**COMMITTEE OF ADJUSTMENT**

**NOTICE OF PUBLIC HEARING**  
**Minor Variance**

<b>APPLICATION NO.:</b>	<b>HM/A-23:304</b>	<b>SUBJECT PROPERTY:</b>	37 Paradise Road South, Hamilton
<b>ZONE:</b>	“C” (Urban Protected Residential)	<b>ZONING BY-LAW:</b>	Zoning By-law former City of Hamilton 6593, as Amended 96-109

**PURPOSE & EFFECT:** So as to permit a Secondary Dwelling Unit – Detached to an existing Single-Family Dwelling notwithstanding that:

**SITE, GRADING, AND SERVICING PLAN**  
OF PART OF  
**LOT 32**  
REGISTERED PLAN 118  
IN THE  
**CITY OF HAMILTON**

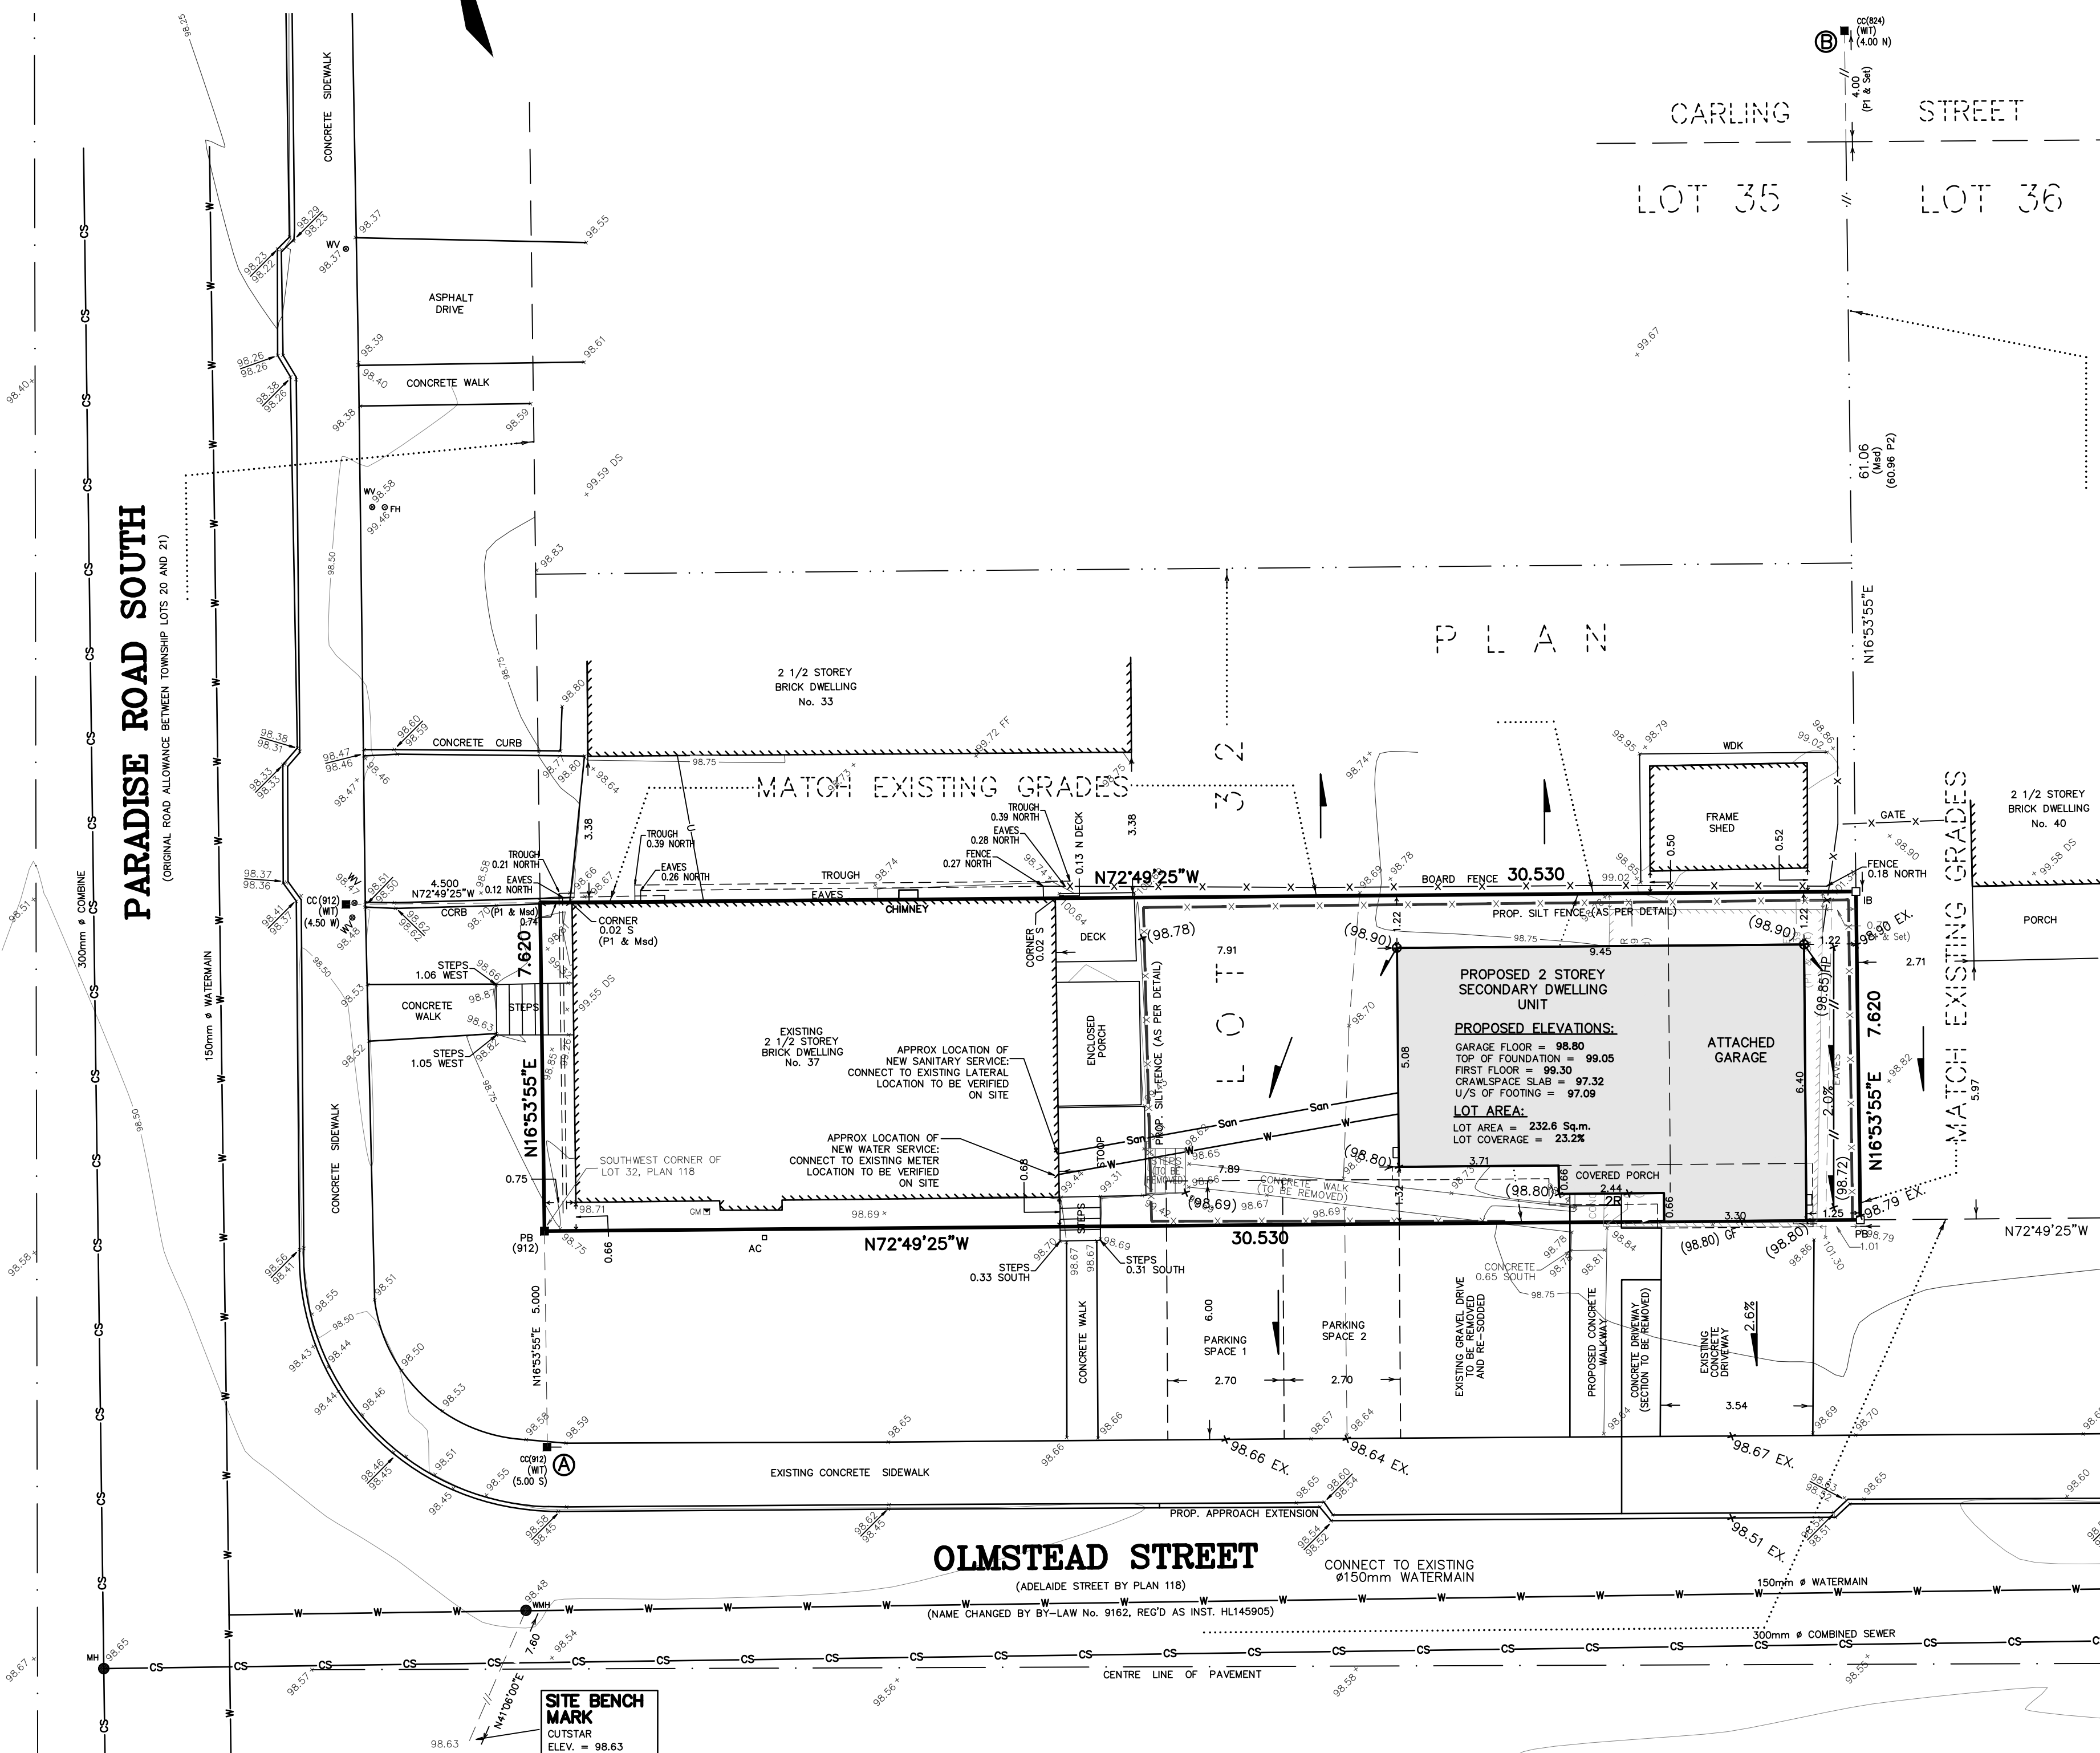
- iii. Be advised, a Divisional interpretation has determined “Curb Level”, as it relates to average grade, shall be taken from the edge of the sidewalk closest to the property line. As per the submitted Grading Plan, the average “Curb Level” is indicated to be 98.5995 and the grade of the garage is indicated to be 98.8. As per Section 1.(a)(iv) of Zoning By-Law Amendment 96-109, the grade of the garage is required to be a minimum of 0.3 metres above average grade. As such, should the proposed grade of the garage not be a minimum of 0.3 metres above average grade as indicated, additional variances may be required.

- iv. Please note, insufficient information has been provided to determine if a landscaped area of 12.0 metres has been provided in accordance with Section 19.(1).2 (xii) of Hamilton Zoning By-Law 6593. Should a 12.0 metres landscaped area within the rear yard not be provided, additional variances may be required.

- v. Be advised, the additional dwelling unit is indicated to be located closer to the exterior side lot line than the existing Single-Family Dwelling. As per Section 19.(1).2 (vii) of Hamilton Zoning By-Law 6593 a Secondary Dwelling Unit – Detached, shall not be located closer to the flankage street than the principal dwelling. As such, should the Secondary Dwelling Unit – Detached be located closer to the street line than the principal dwelling, additional variances may be required.

- vi. Please be advised a Residential Boulevard Parking Agreement with the Hamilton Municipal Parking Authority may be required for the parking space shown to encroach on the Olmstead Street road allowance.

In addition to the above comment, it appears the eaves/troughs of the proposed Secondary Dwelling Unit - Detached is within the Olmstead Street road allowance. As such, an Encroachment Agreement with public works may be required for the eaves/troughs within the road allowance.

**LEFT ELEVATION**  
 WALL AREA = 347 SF.  
 ALLOWABLE OPENING \*71 = 59 SF.  
 STANDARD PROPOSED OPENING = 6 SF.

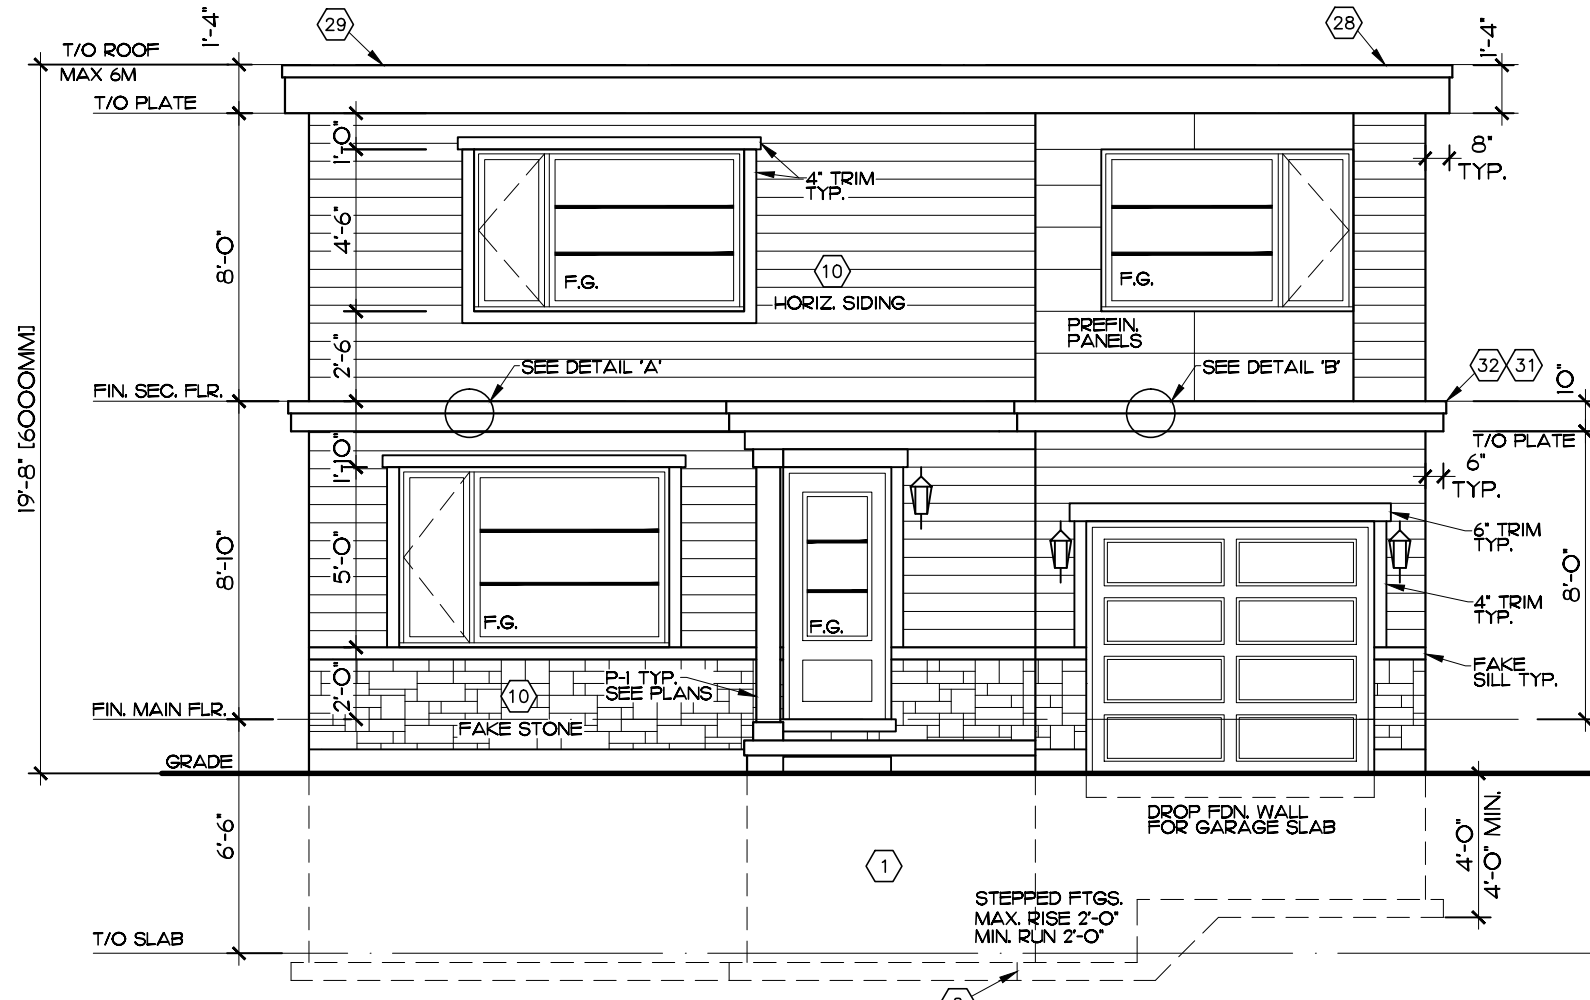
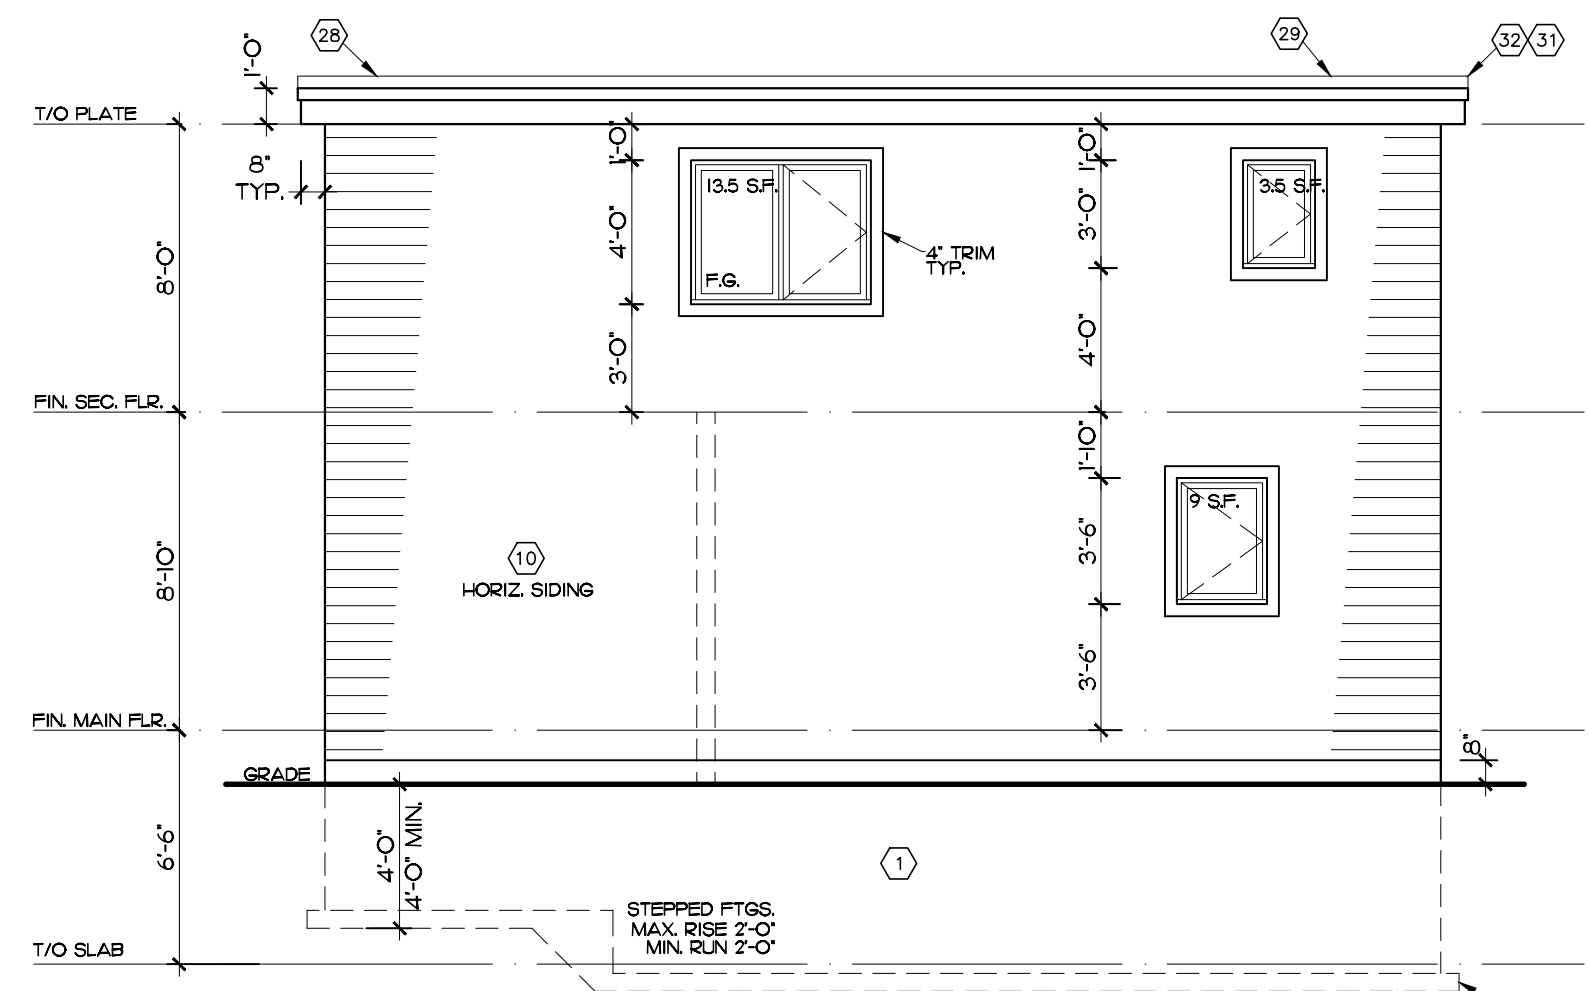
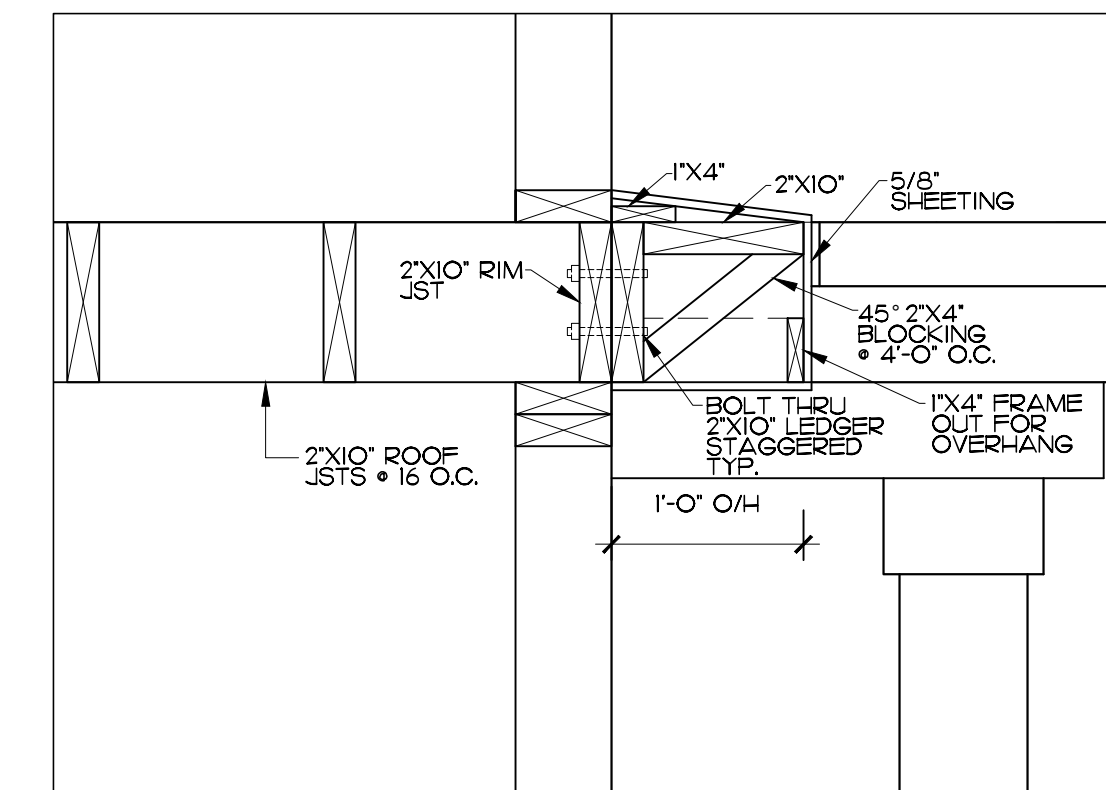
- i. Be advised, it appears the elevation of the “Crawl Space”, as indicated on the Elevation drawings, is shown to be 1.98 metres in height. As per a Divisional Policy ZON 006 in reference to Building Code Section 9.18.1.1, a Crawl Space must be less than 1.8 metres in height otherwise it shall be considered a basement or cellar. As such, the “Crawl Space” as indicated on the submitted material may be considered a cellar and would be included within the calculation of Gross Floor Area as per Section 1.(a)(ii) of Zoning By-Law Amendment 96-109.

Furthermore, it is unclear the total Gross Floor Area of the “Crawl Space” and if a portion of the area is intended to function as HVAC Equipment and Laundry Facilities. Please note, a maximum of 9.3 m<sup>2</sup> may be used for laundry facilities and a maximum of 6.5m<sup>2</sup> may be used for HVAC equipment. Be advised, should the inclusion of the Gross Floor Area of the cellar, minus any applicable area exclusions, result in a Gross Floor Area ratio greater than 1.23, additional variances may be required.

- ii. Please note, in addition to the above comments should the “Crawl Space” be 1.8 metres or higher, the Gross Floor Area of the proposed Secondary Dwelling Unit – Detached will exceed the maximum permitted Gross Floor Area of 75m<sup>2</sup>, as required under Section 19.(1).2 (xi) of Hamilton Zoning By-Law 6593. Should the Gross Floor Area exceed the permitted 75m<sup>2</sup>, additional variance may be required.
